UNITED STATES PATENT AND TRADEMARK OFFICE

APPLICATION NO.	FILING DATE	FIRST NAMED INVENTOR	ATTORNEY DOCKET NO.	CONFIRMATION NO.
10/767,743	01/30/2004	Christian Bauer	713-1009	5720
33712	7590	06/06/2006	EXAMINER	
LOWE, HAUPTMAN, GILMAN & BERNER, LLP (ITW)			REESE, DAVID C	
1700 DIAGONAL ROAD			ART UNIT	
SUITE 300			PAPER NUMBER	
ALEXANDRIA, VA 22314			3677

Office Action Summary	Application No. 10/767,743	Applicant(s) BAUER, CHRISTIAN	
	Examiner David C. Reese	Art Unit 3677

THIS NON-FINAL ACTION IS RESPONSIVE TO THE AMENDMENT FILED 2/1/2006.

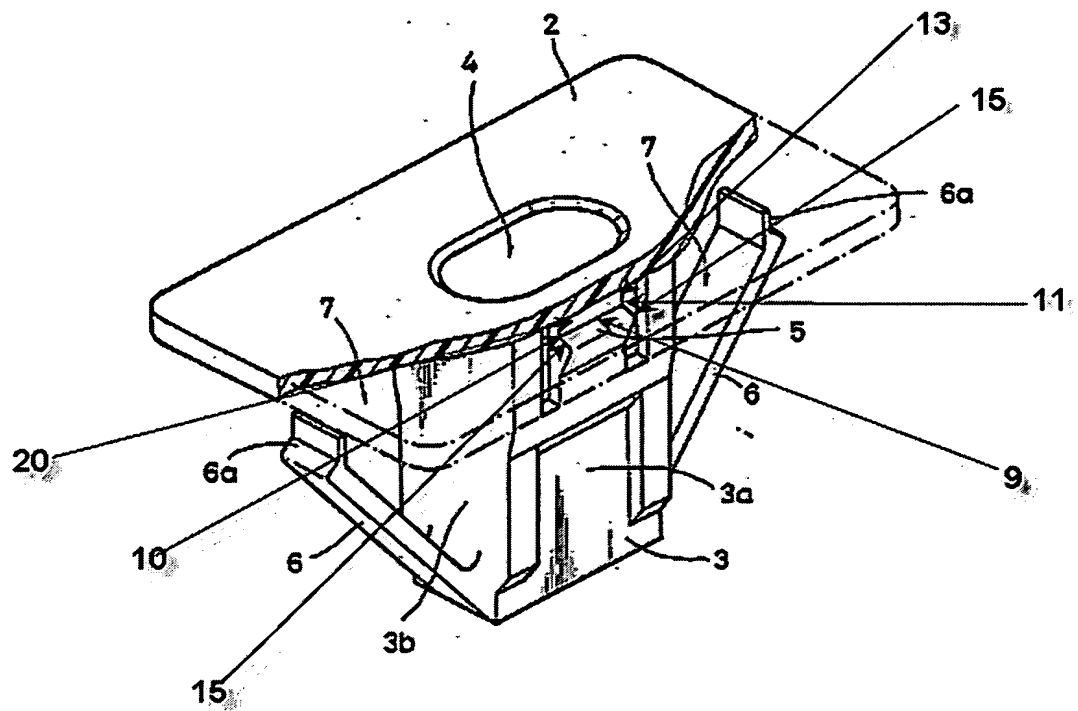
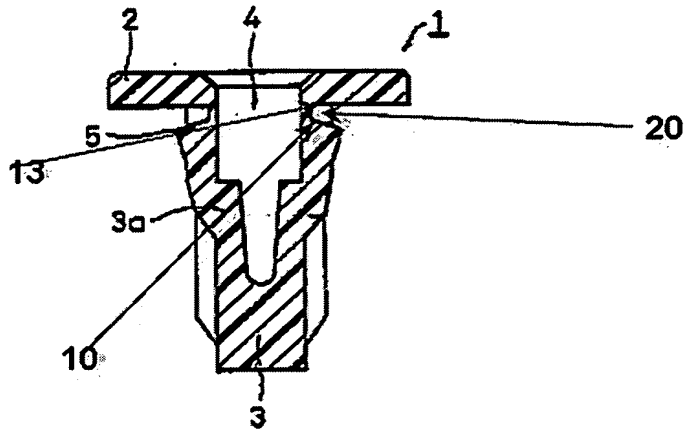
[5] Claims 6-10, 12-16, 19-20, and 28-30 are rejected under 35 U.S.C. 102(b) as clearly anticipated by Sato, US- 4,927,306, because the invention was patented or described in a printed publication in this or a foreign country, or in public use or on sale in this country more than one (1) year prior to the application for patent in the United States.

As for Claim 6, Sato teaches of a fastener (1, see figures below) adapted to be inserted into an opening of a sheet member (11) having opposite upper (2) and lower surfaces (3), said fastener (1) comprising:

a shank (3) extending in an axial direction of said grommet and having opposite upper (2) and lower ends (1);

at least a locking tab (6a) coupled to said shank (3) between the upper (2) and lower ends (3) of said shank (3) and radially flexible relative to said shank (3); and

a head (2) connected to the upper end of said shank (3) and comprising a flange (2) adapted to engage the upper surface of the sheet member (11) when said shank (3) and said locking tab (6a) are snapped into the opening (12);

wherein said shank (3) comprises

a shoulder (5) in a region adjacent the head (2), said shoulder (5) being adapted to be placed below an edge of the opening (12) when said shank (3) is moved transversely to said axial direction after being snapped into the opening, thereby preventing withdrawal of said shank (3) from said opening (12); and

an outer surface section (20) inclined relative to the axial direction and connecting said shoulder (5) and the lower surface of said head (2), for engaging the edge of the opening (12) and drawing said shank (3) into the opening (12) when said shank (3) is moved transversely to said axial direction; and

wherein, when said shank (3) is seen in said axial direction, said shoulder (5) is confined between an outer edge (15) of said shank (3) and a first boundary line (9) intersecting said outer edge (15) at first (10) and second points (11), and said outer surface section (20) is confined between said first boundary line (9) and a second boundary line (13) converging toward the first point (10).

[8] Applicant's arguments filed 2/1/2006 regarding rejections under 35 U.S.C. 102 have been fully considered but they are not persuasive. With regard to the amended subject matter, the examiner directs the applicant to the figures above showing how the claim language in the instant set of claims, when viewed with the broadest reasonable interpretation, are anticipated by the figures of Sato.
